Application to Amend a Planning Permit S72

Planning Application No:	PLA0044/23
Address:	14 BURTONWOOD CRT, NEERIM SOUTH

Change to alignment of lot boundaries and increase the area of the lot with existing dwelling.

**REQUEST TO CHANGE SUBDIVISION LAYOUT (Condition 2.) and OBTAIN
WRITTEN CONSENT FROM RESPONSIBLE AUTHORITY**

SUBDIVISION PLAN
SCALE **PROVISIONAL** 1:250 MTS.

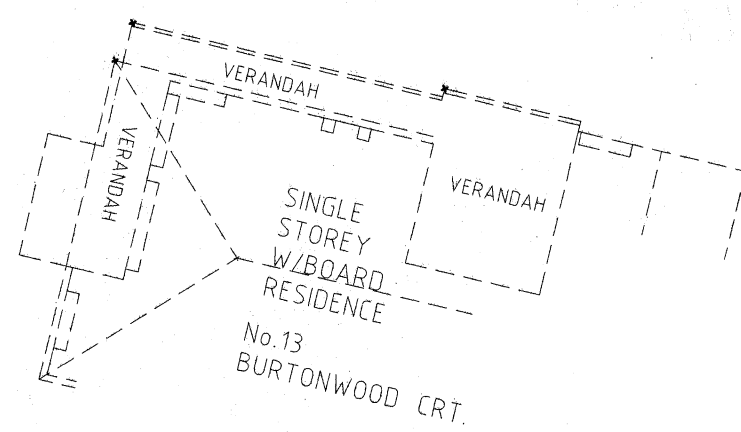
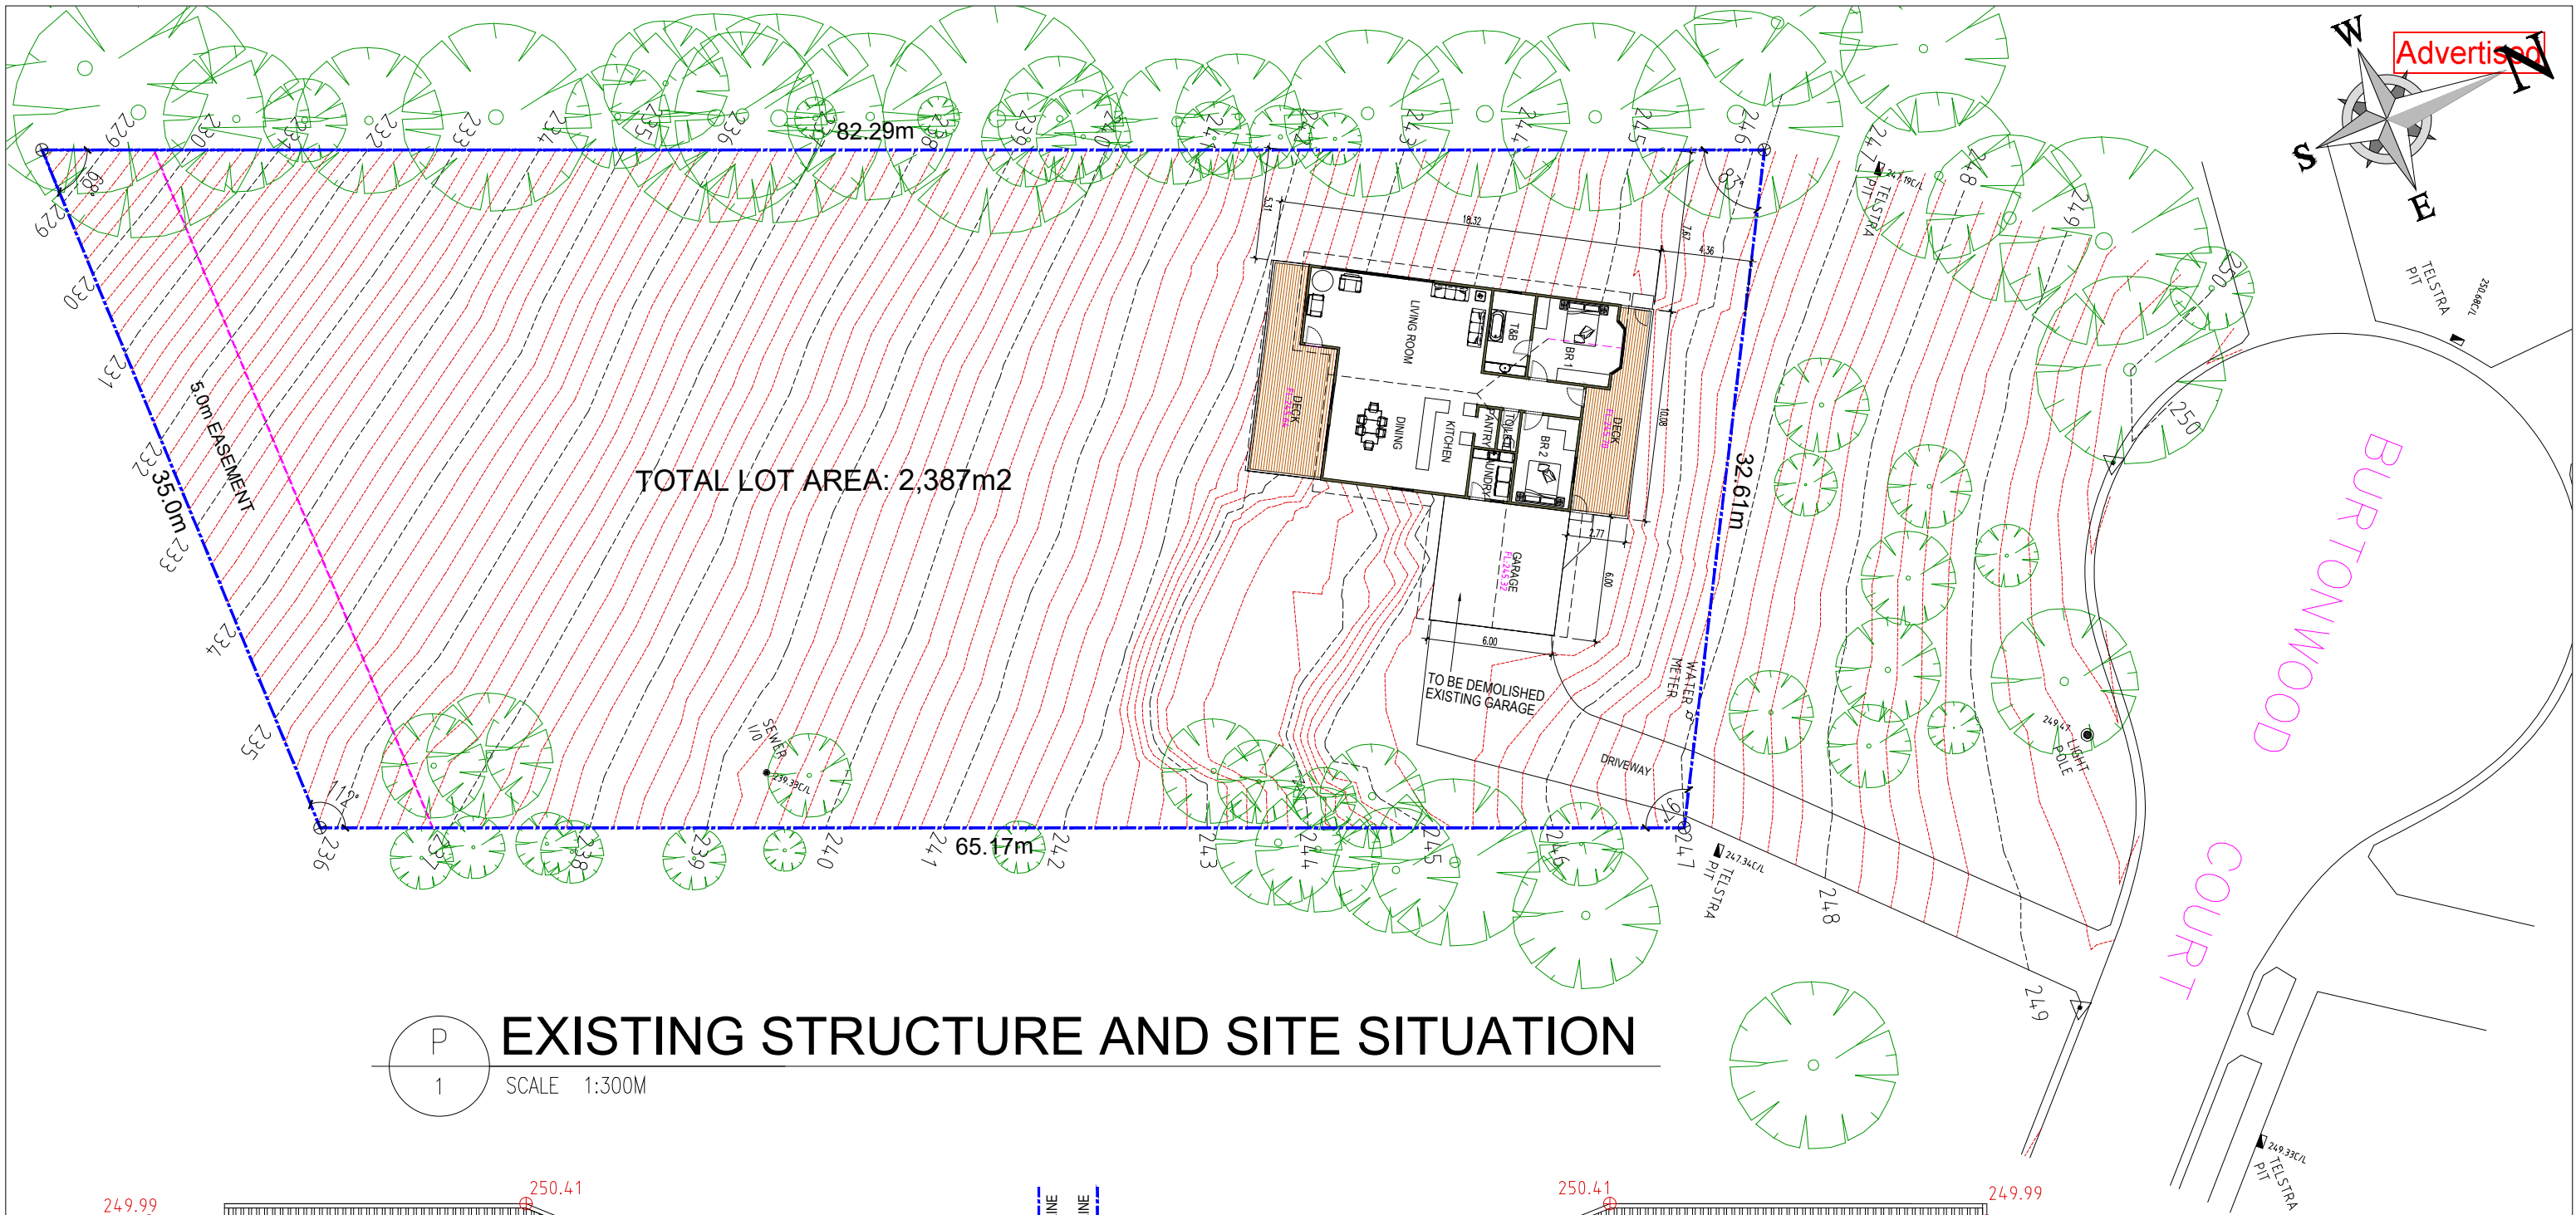
I now wish to proceed with the proposal to alter lot boundaries and submit for your consideration new plans P01 Existing, P02 Provisional Subdivision (pending new plans from Surveyor) and P03 Site Services.

The proposed (amended) design also responds to site and context features in local planning policy and Neighbourhood Character considerations. The only amendment sought is to change the subdivision boundaries that will enlarge Lot 1 to 815m² (from 598m²) where an existing house is located. Lot2 will be reduced in area to 1,572m² (both provisional pending Survey Drawing) which coincidentally is a little larger than the average lot size in Cunliffe Estate.

Figure 4: Map of TPZ fencing and the areas to supervise excavation (NearMap 2025)

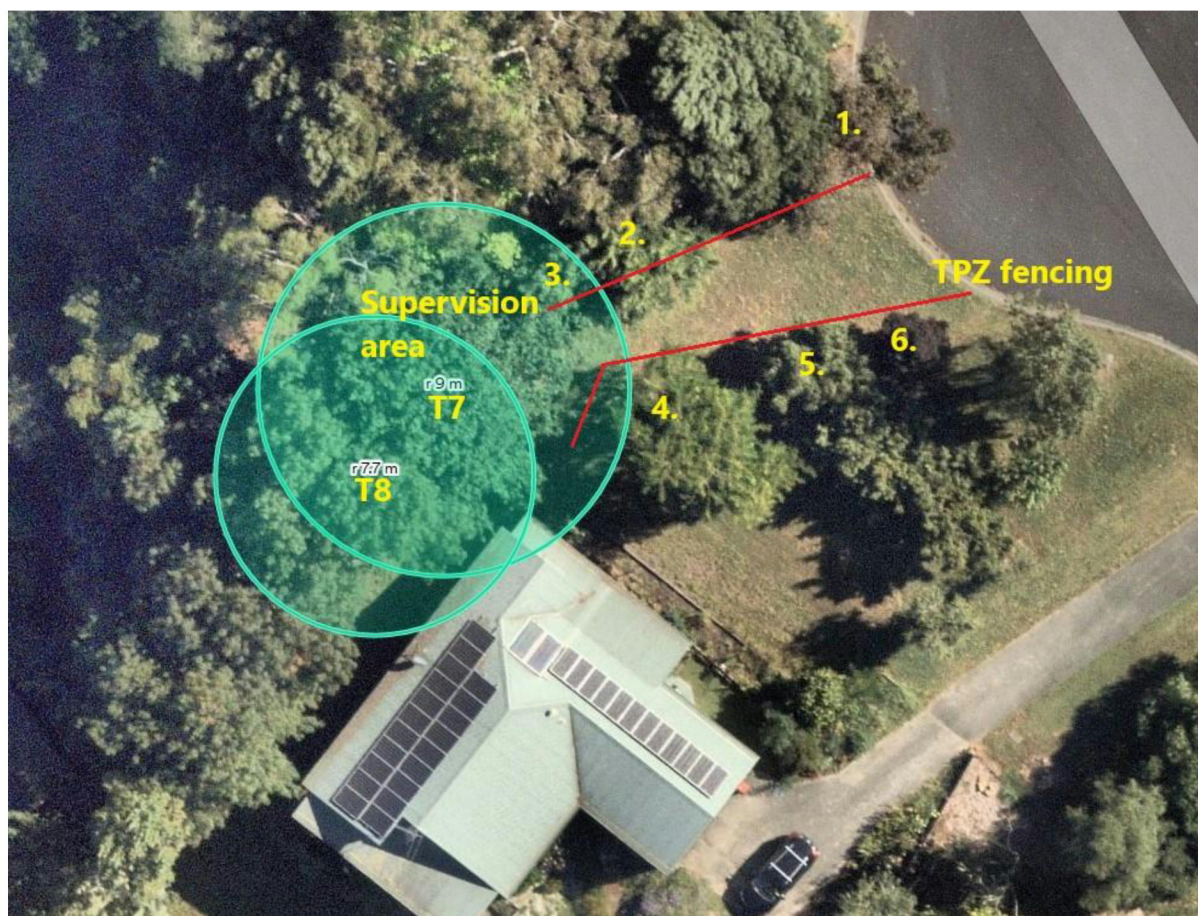
1. Any excavation for cut within the tree protection zone of tree 7 is to be supervised by the nominated project arborist as outlined above (Figure 4.)
